STATE OF MAINE
DEPARTMENT OF TRANSPORTATION
☐ Approved ☒ Returned for Corrections
SEP 14 1997
☒ Approved as noted ☐ Rejected

DESCRIPTION Timber Railing
PROJECT Winter St. Bridge Over Maine DOT Railroads
LOCATION BATH, MAINE SAGadahoc COUNTY
DESIGNER _____
CUSTOMER MAINE DEPT. OF TRANS.
DRAWN BY ARK/KND DATE 8-25-97 JOB NUMBER 77-76 DWG. NO. E1
CHK'D BY _____ DATE _____

GLULAM TIMBER HANDRAIL

GLULAM TIMBER GUARD RAIL				
TOLERANCES (EXCEPT AS NOTED)		REVISIONS		
DECIMAL	NO.	DATE	BY	
2	1			
FRACTIONAL	2			
2	2			
ANGULAR	3			
2	3

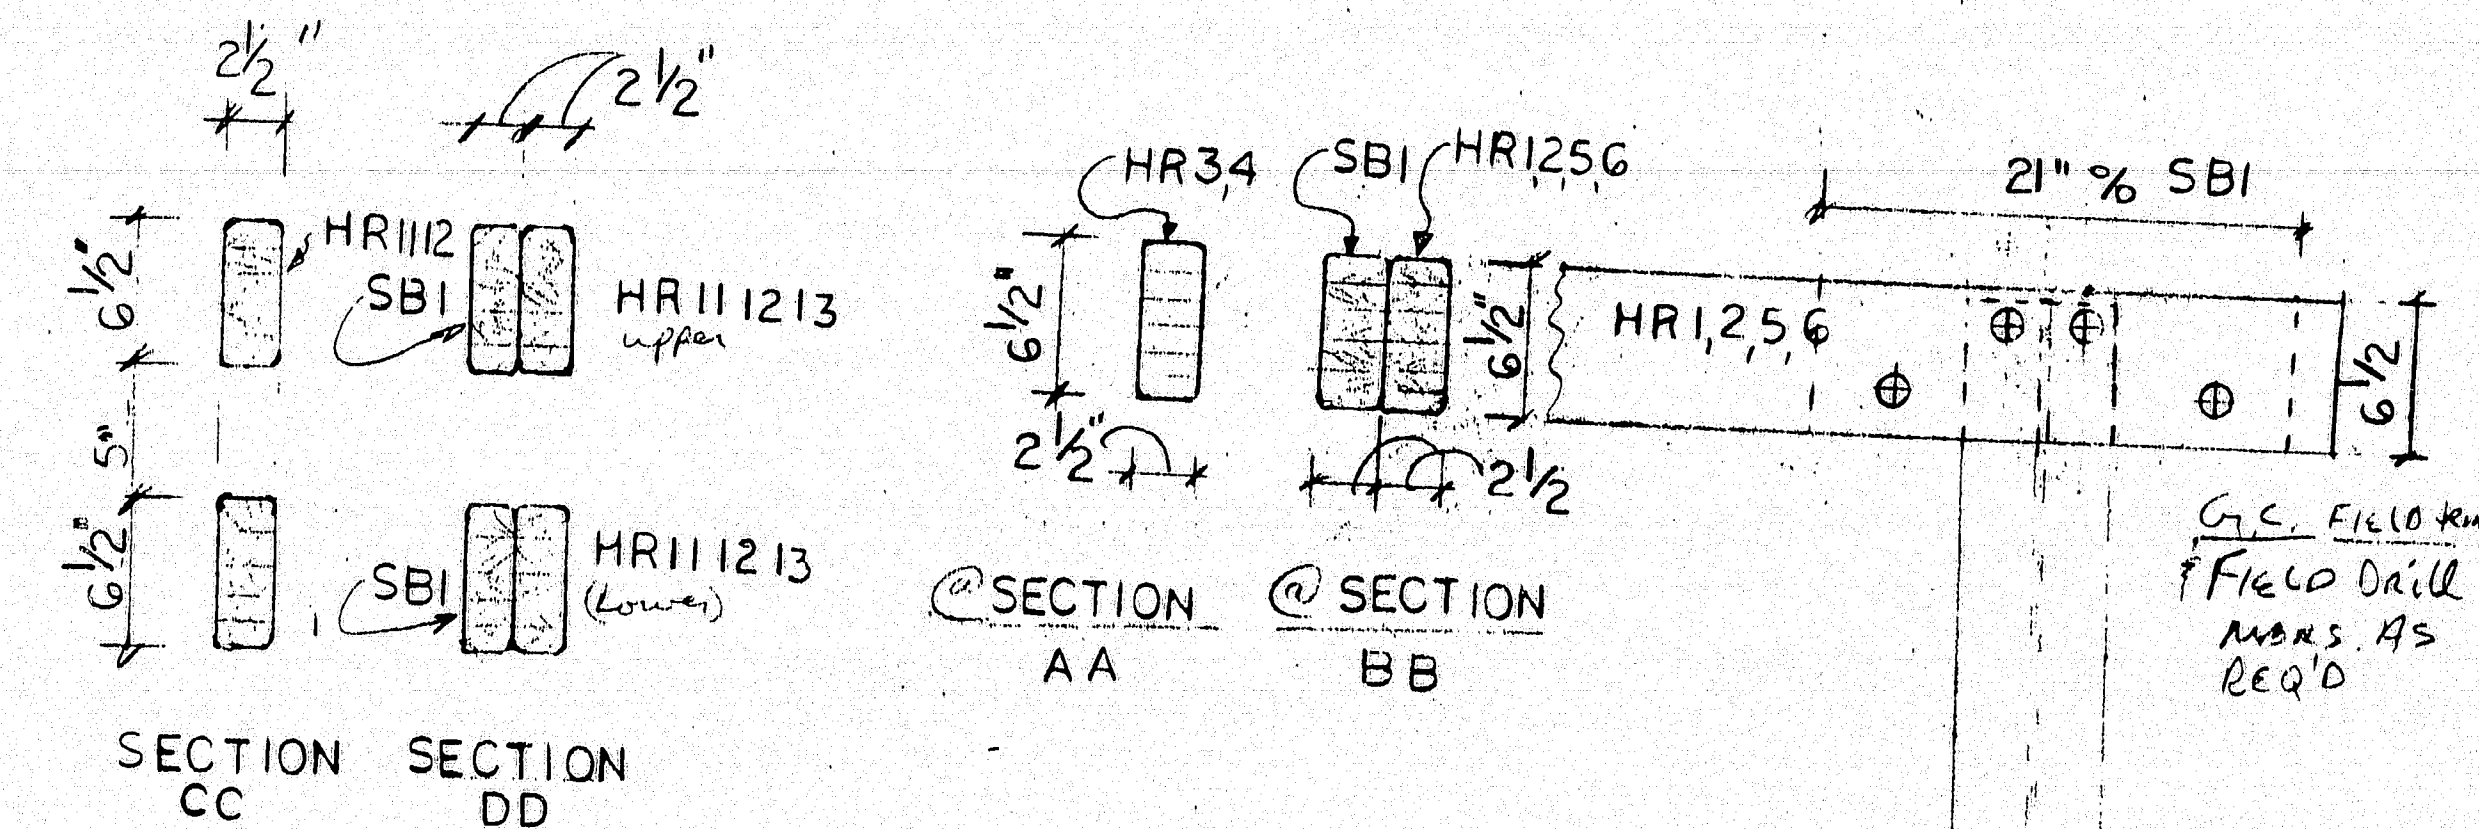
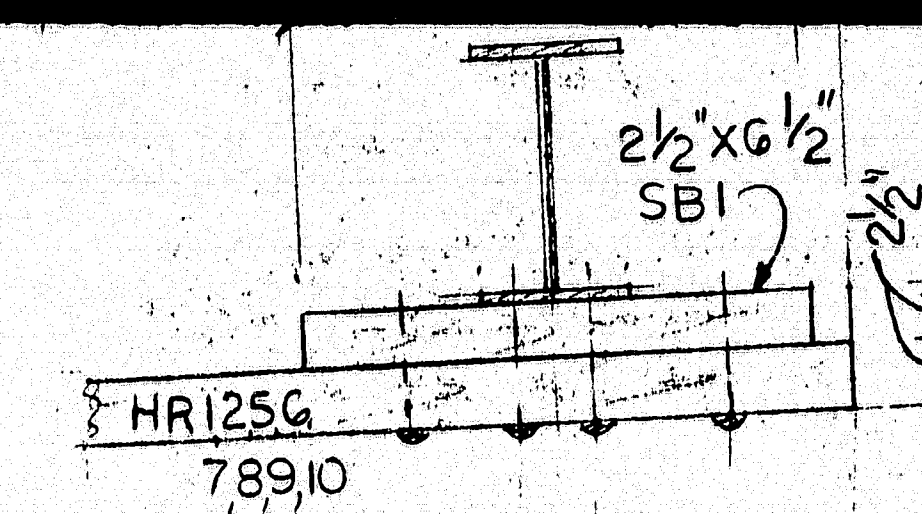
Each strand length
should be attached to
a Minimum of
Three posts.

See Note 13 of
Sat 4 of 4 Dos. Day

Combine some
lengths 2.

X-SECTION GUARD RAILS GR1-9
24F-V3 SQ.Y. PINE, ARCH. GD.
CCA 6 #/CF, NO CAMBER.

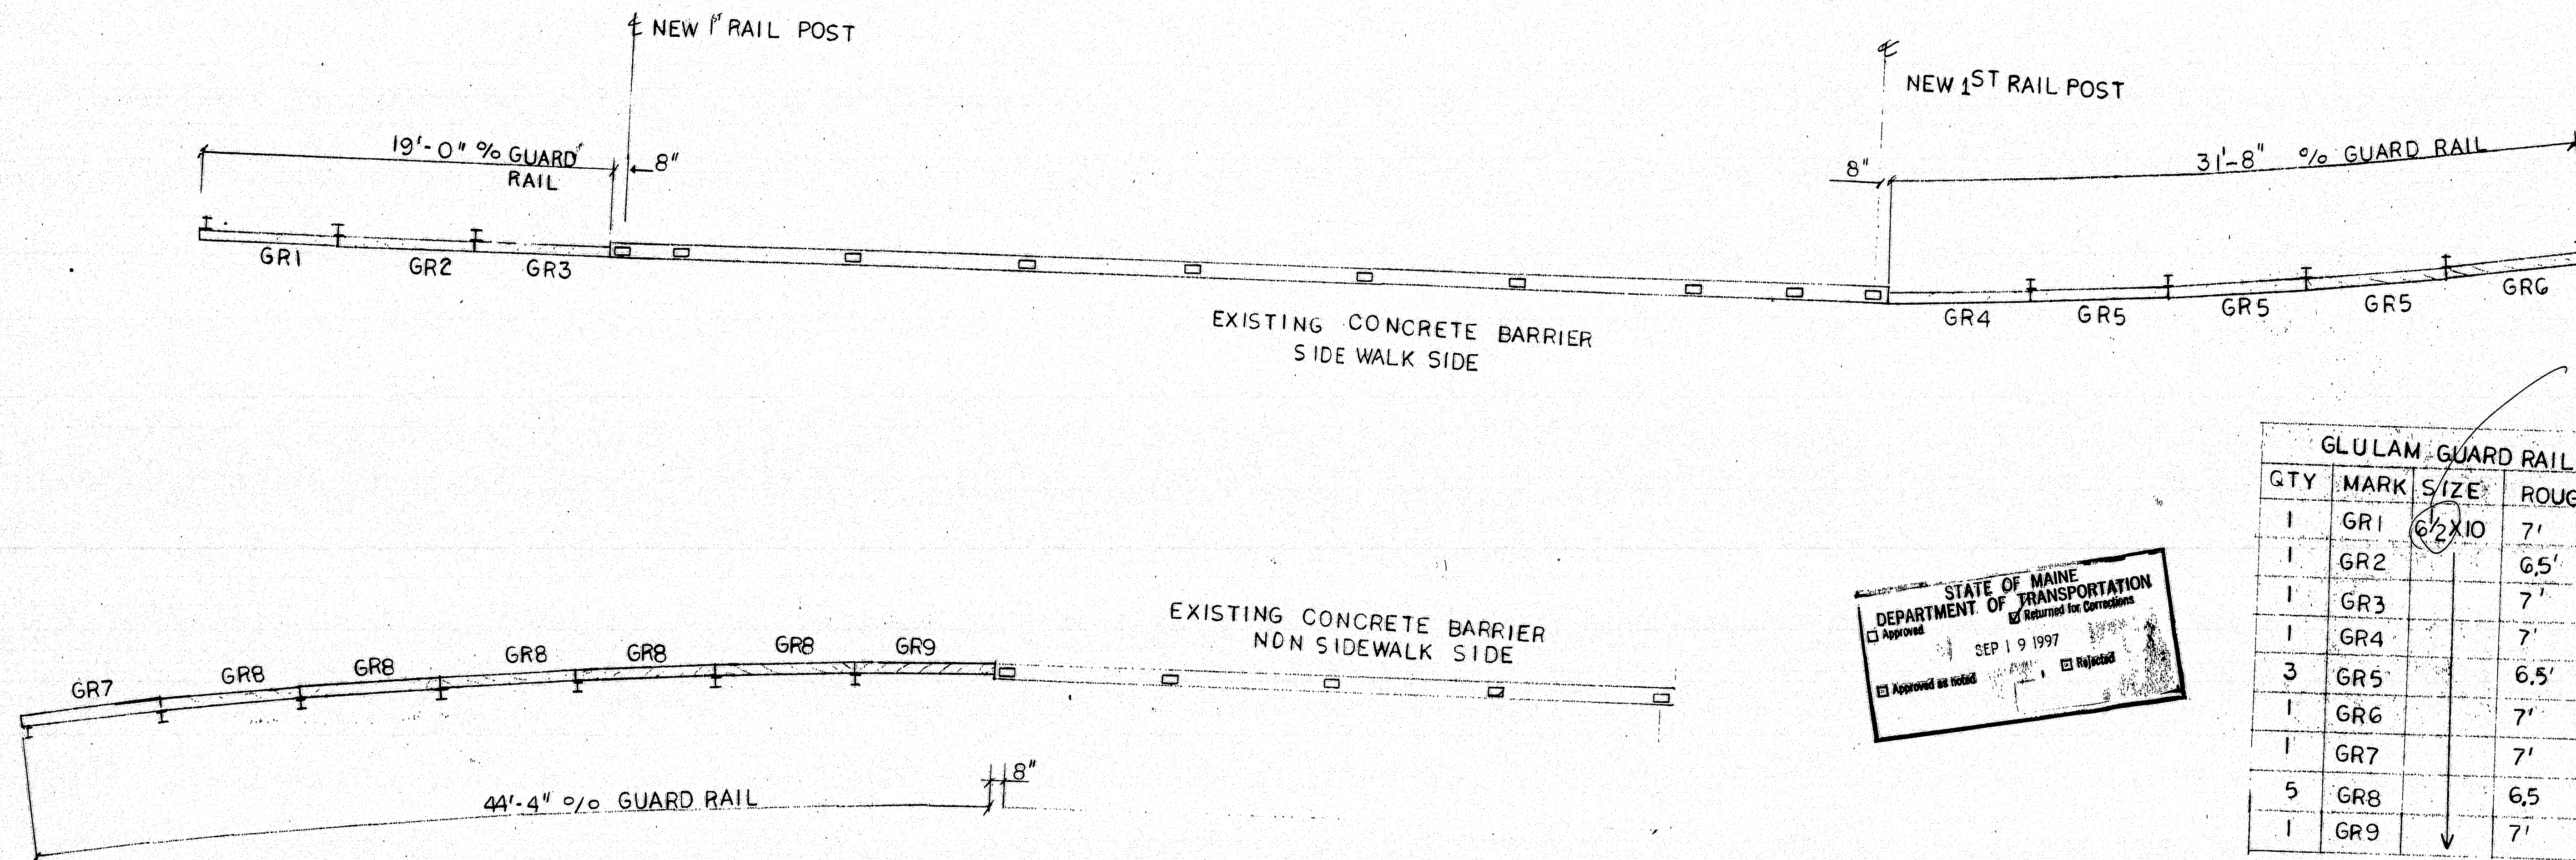
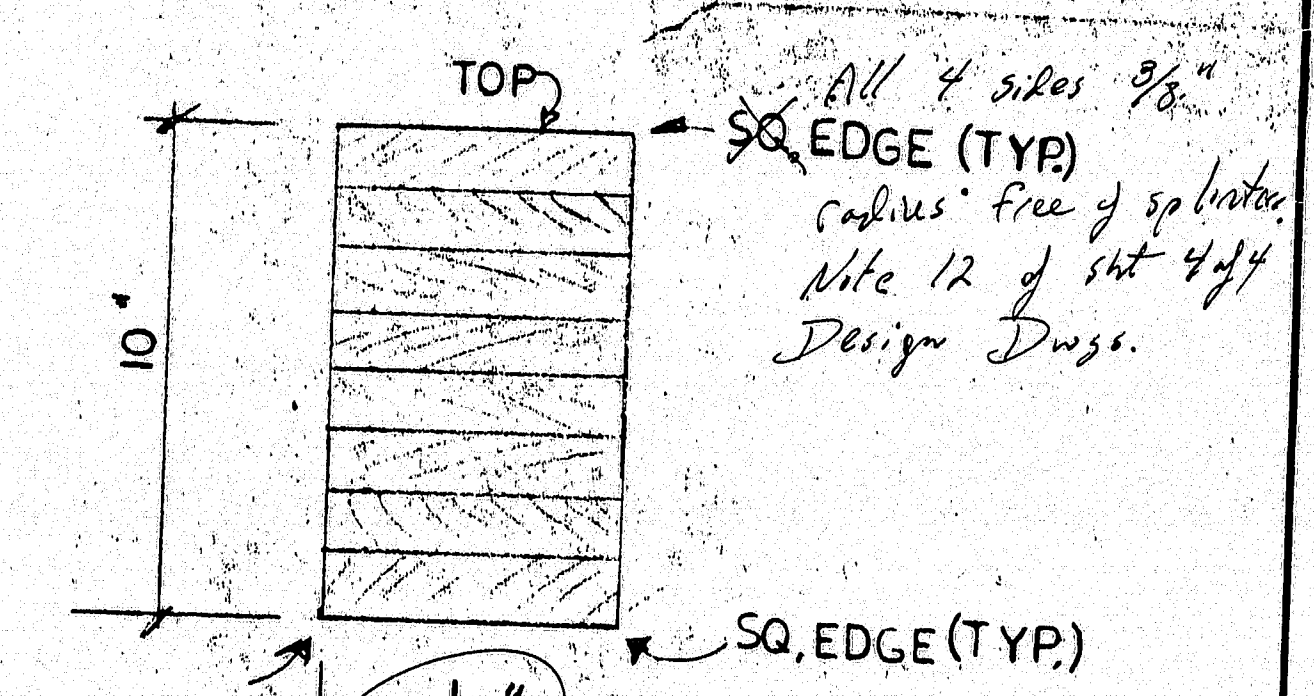
*See Notes 12 & 13
Design Draw.*

*Timber Hardware shall be cut to
and holes drilled to fit in the field.*

*8" x 10" Guardrail Timber shall be dressed
prior and preshielded before treatment.*

*See Note 11
or sub 4 of
Design Draw.*

*Applied in accordance
with requirements of
ASTM A 133.
Timber to be field
to a moisture content
of 19% or less
after treatment.*

*Field cuts & holes shall
be treated with two heavy
coats of Chromated Copper Arsenate
applied with a brush or
spray. See Note 13 sub 4 of
Design Draw.*
